1955 PITTWATER ROAD, BAYVIEW

S4.55 AMENDED PLANS

DRAWING LIST

Drawing Title First Floor Comparison Plan		Project No. A22039
SCALE As indicated	@ A3 Drawing no: DA.905	ISSUE A

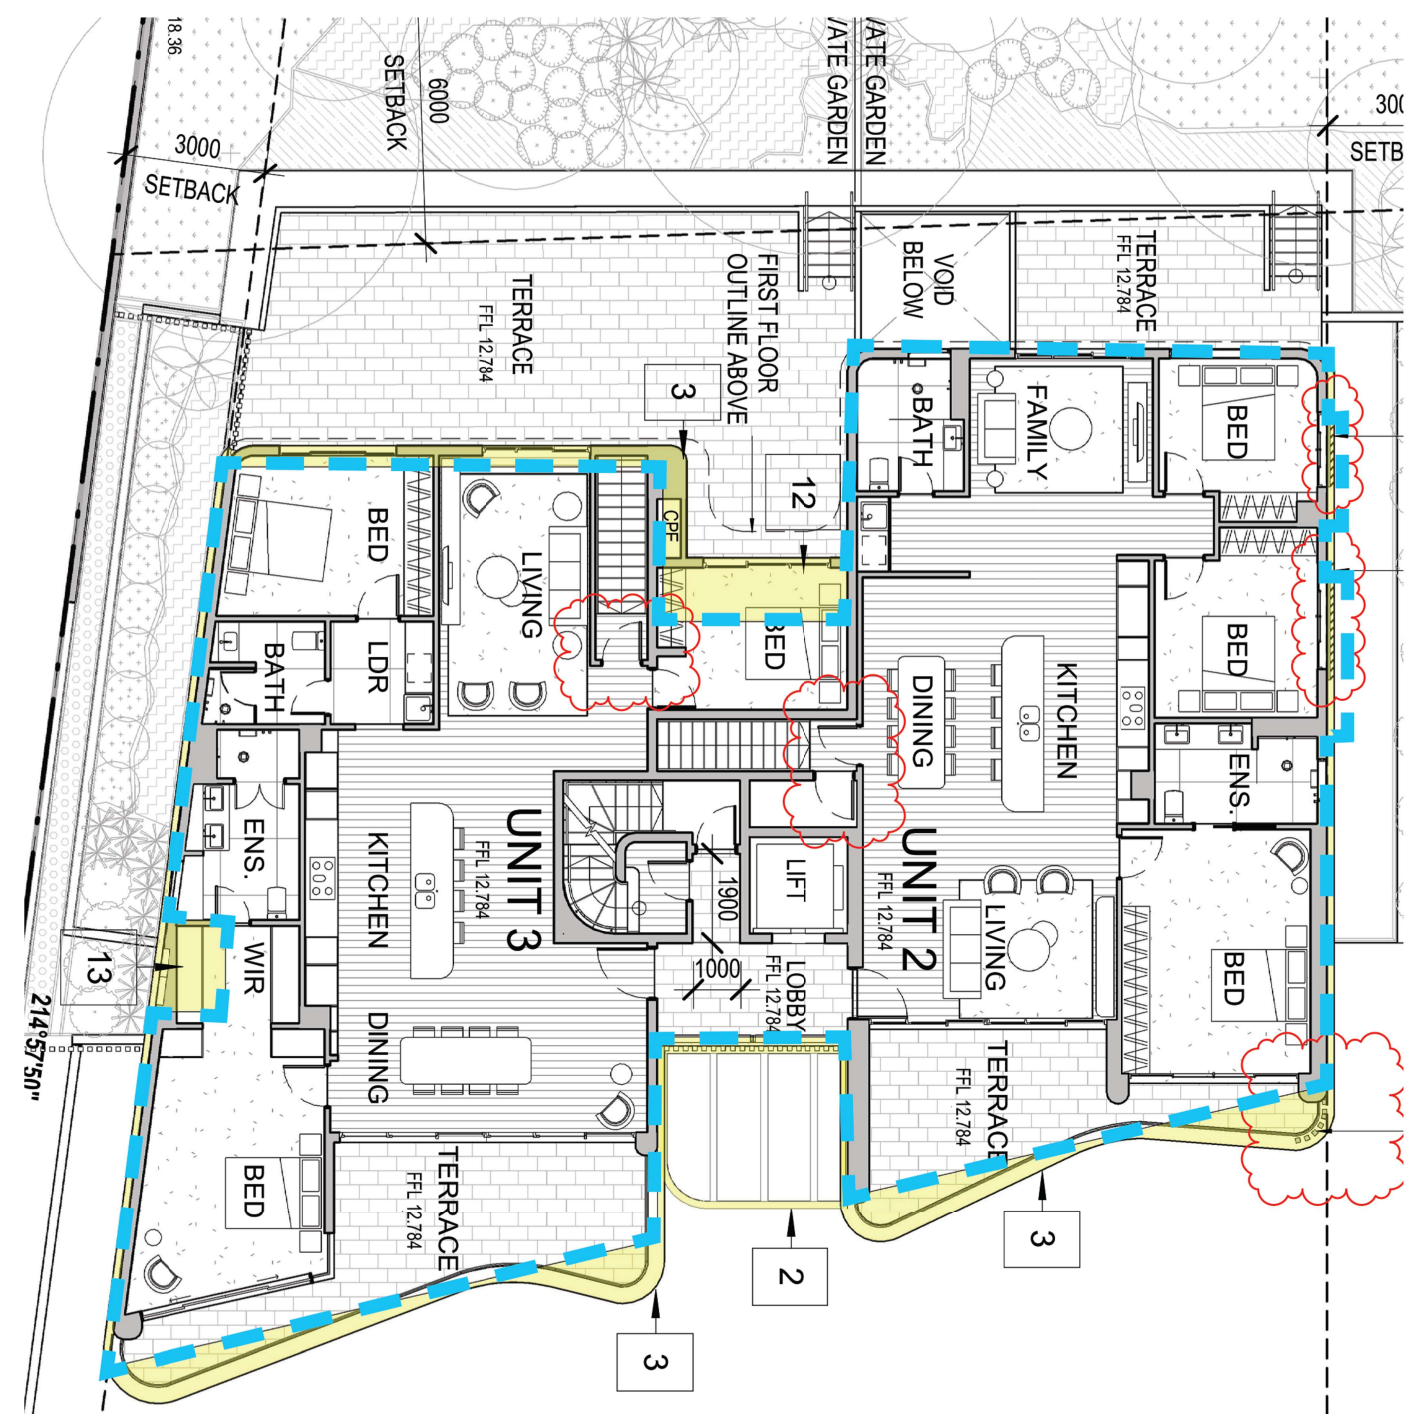
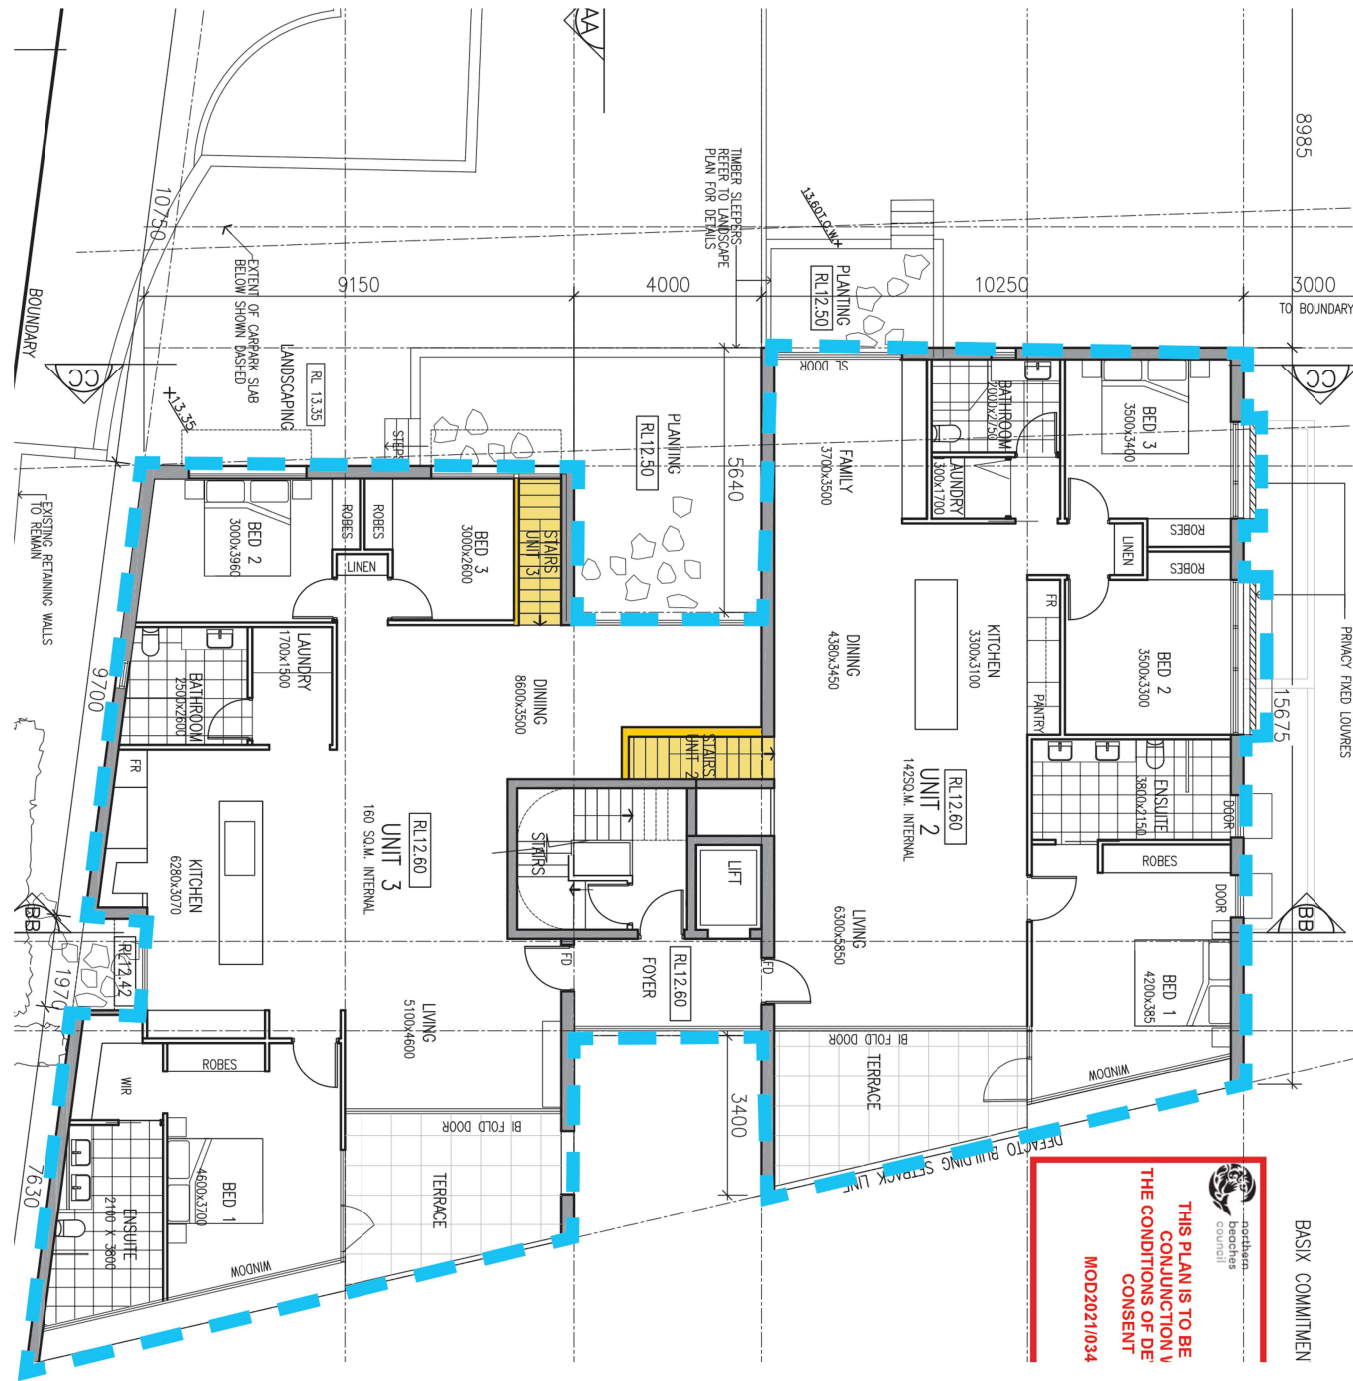
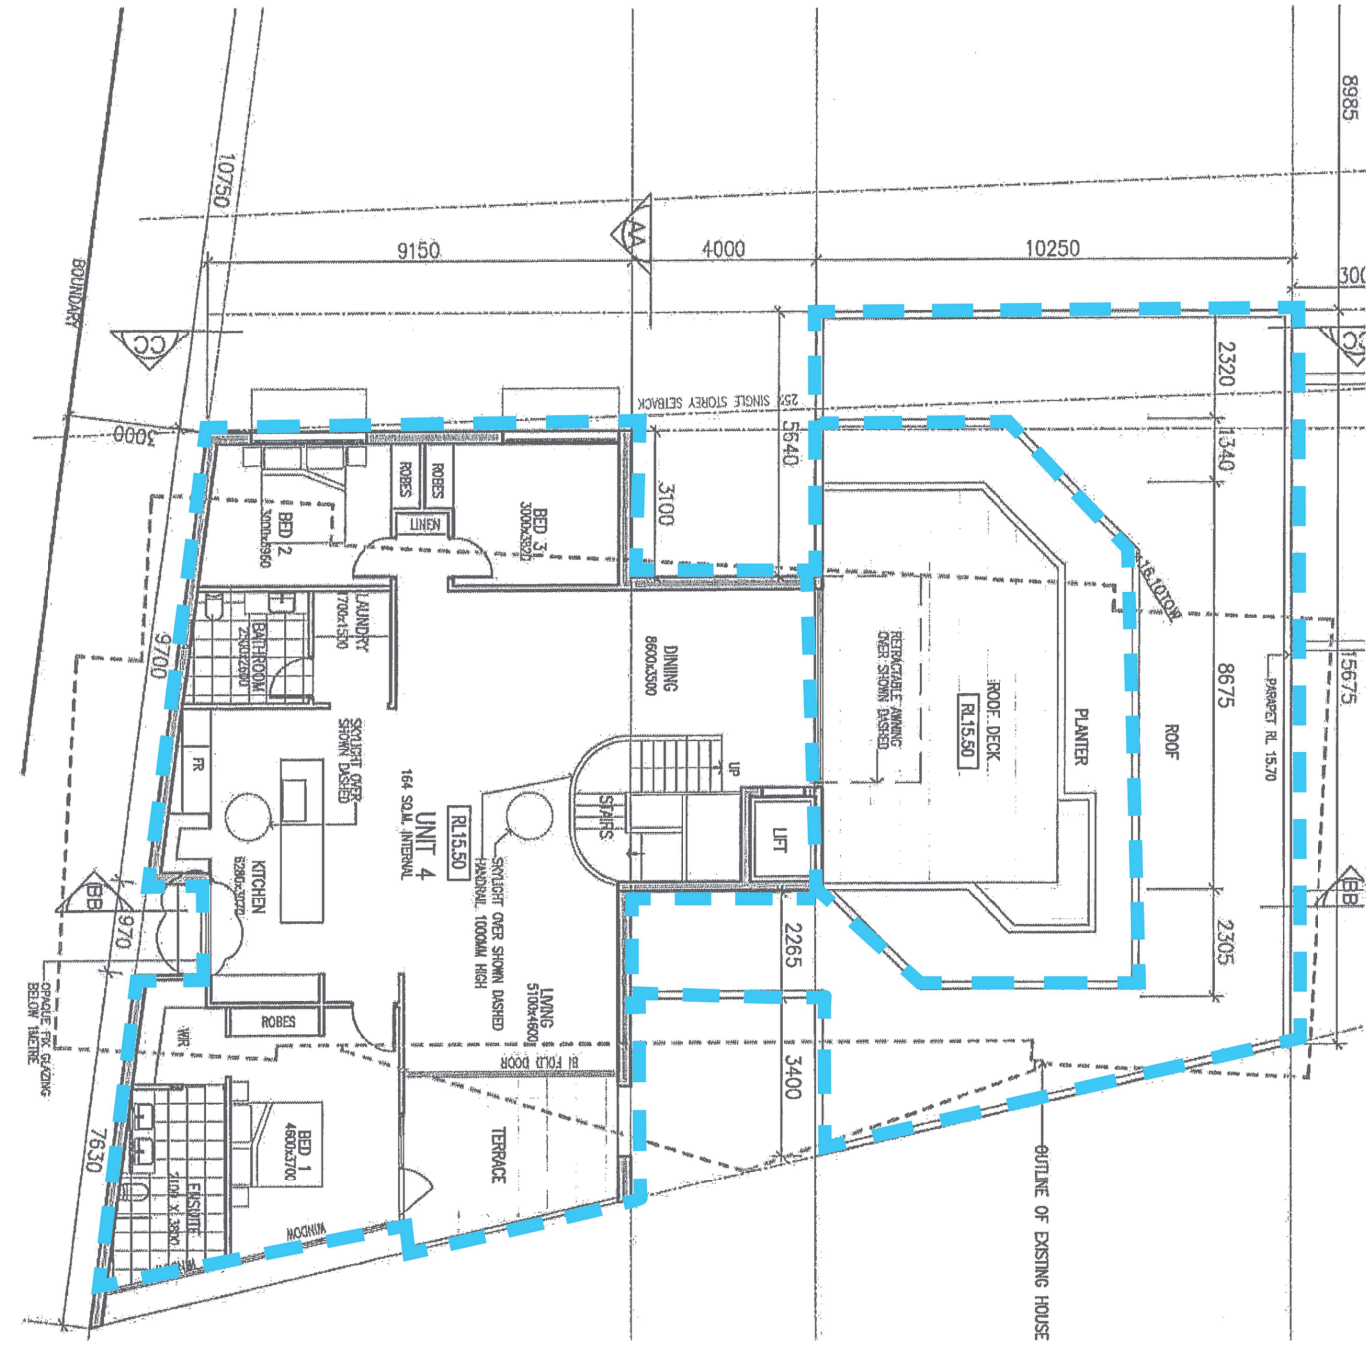
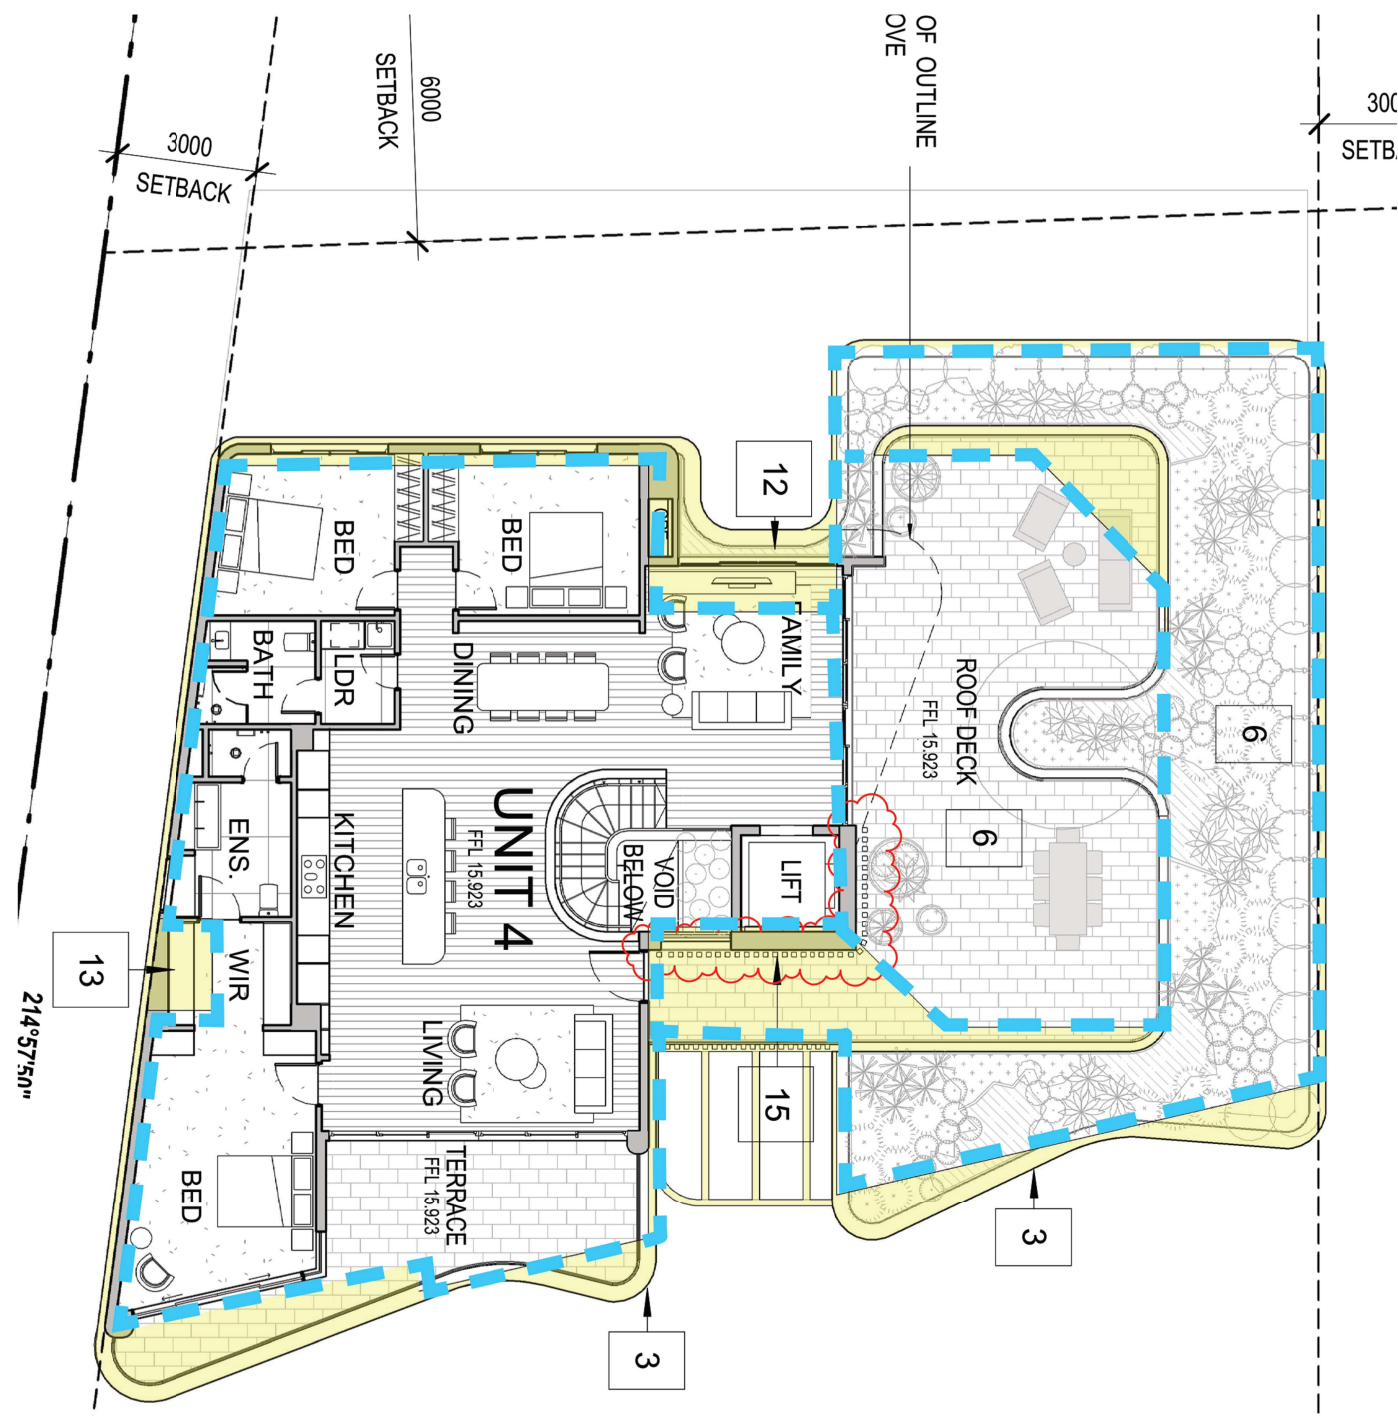
■ S4.55 MODIFICATIONS

NORTH ELEVATION

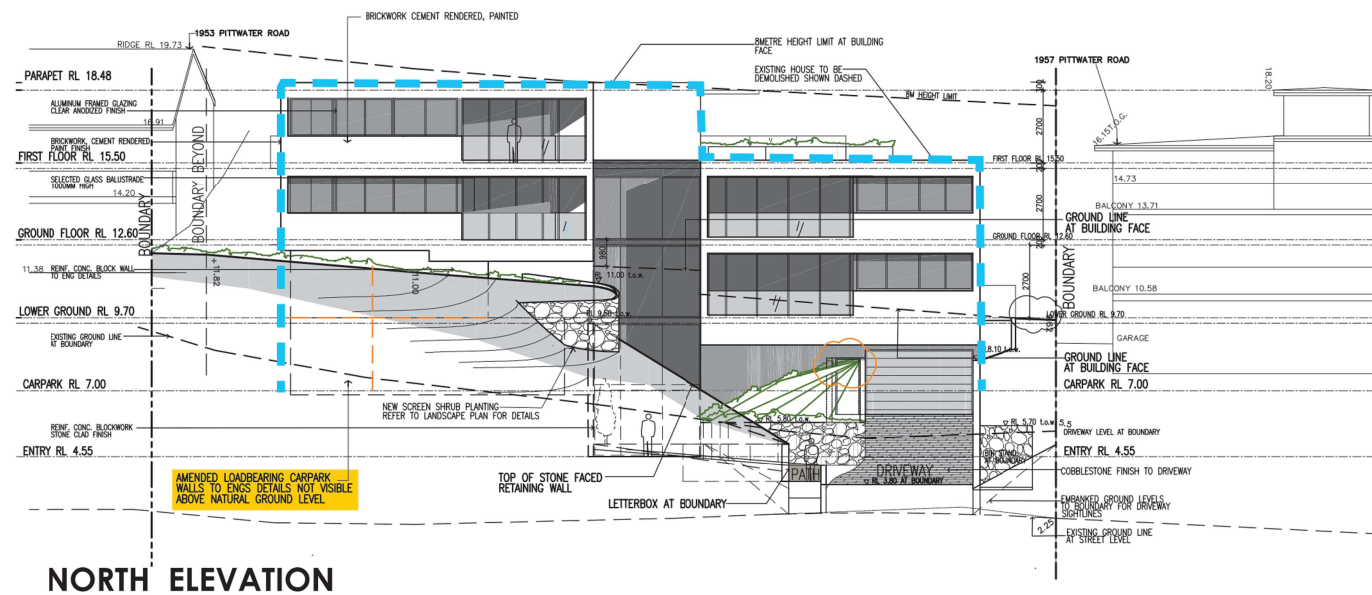
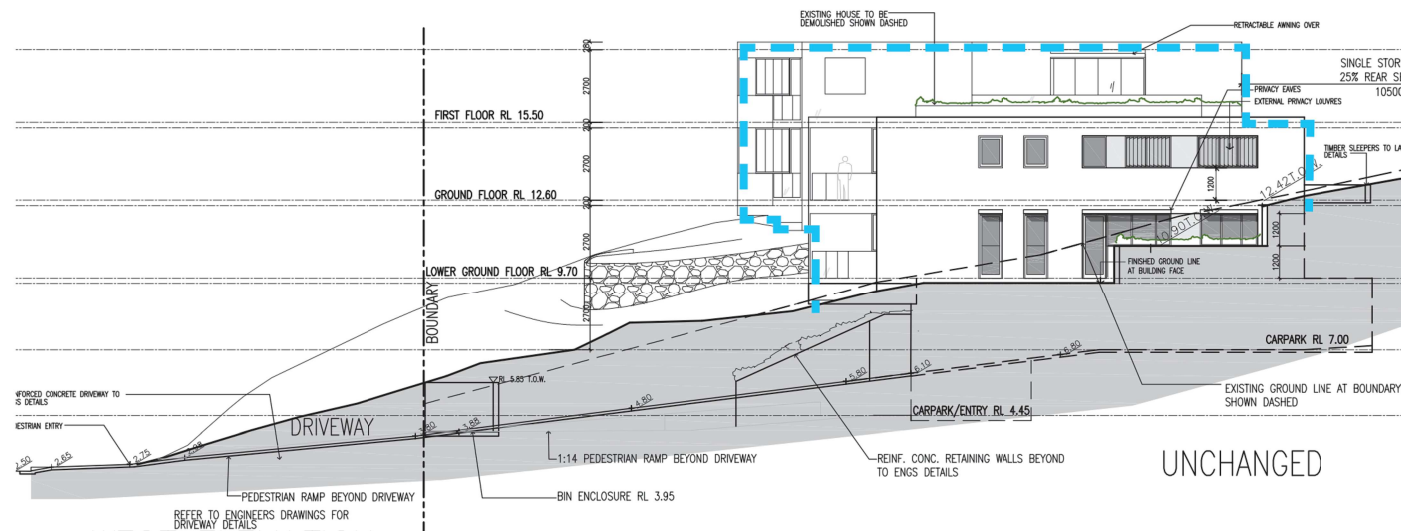
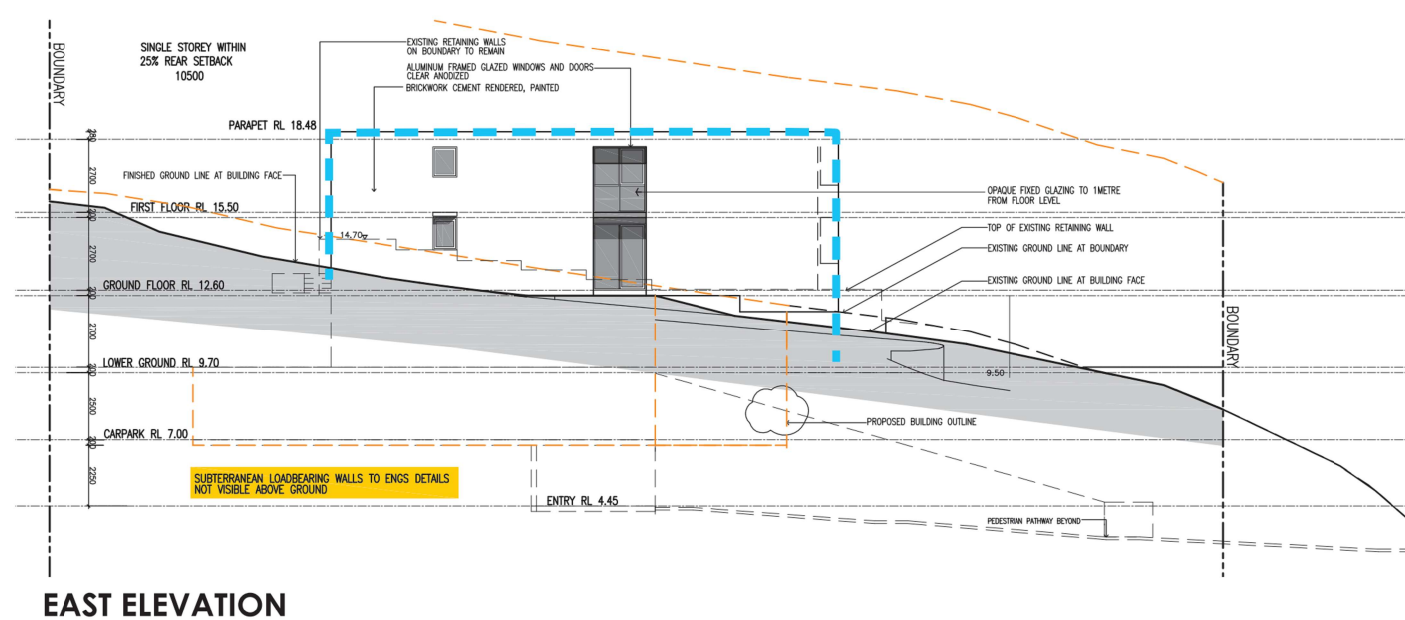
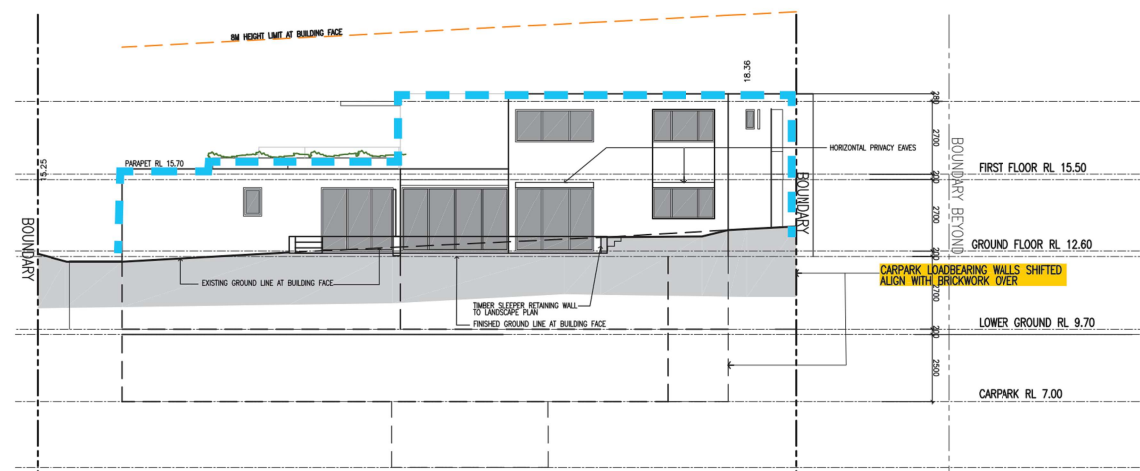
— — — APPROVED BUILDING
OUTLINE MOD
2021/0101
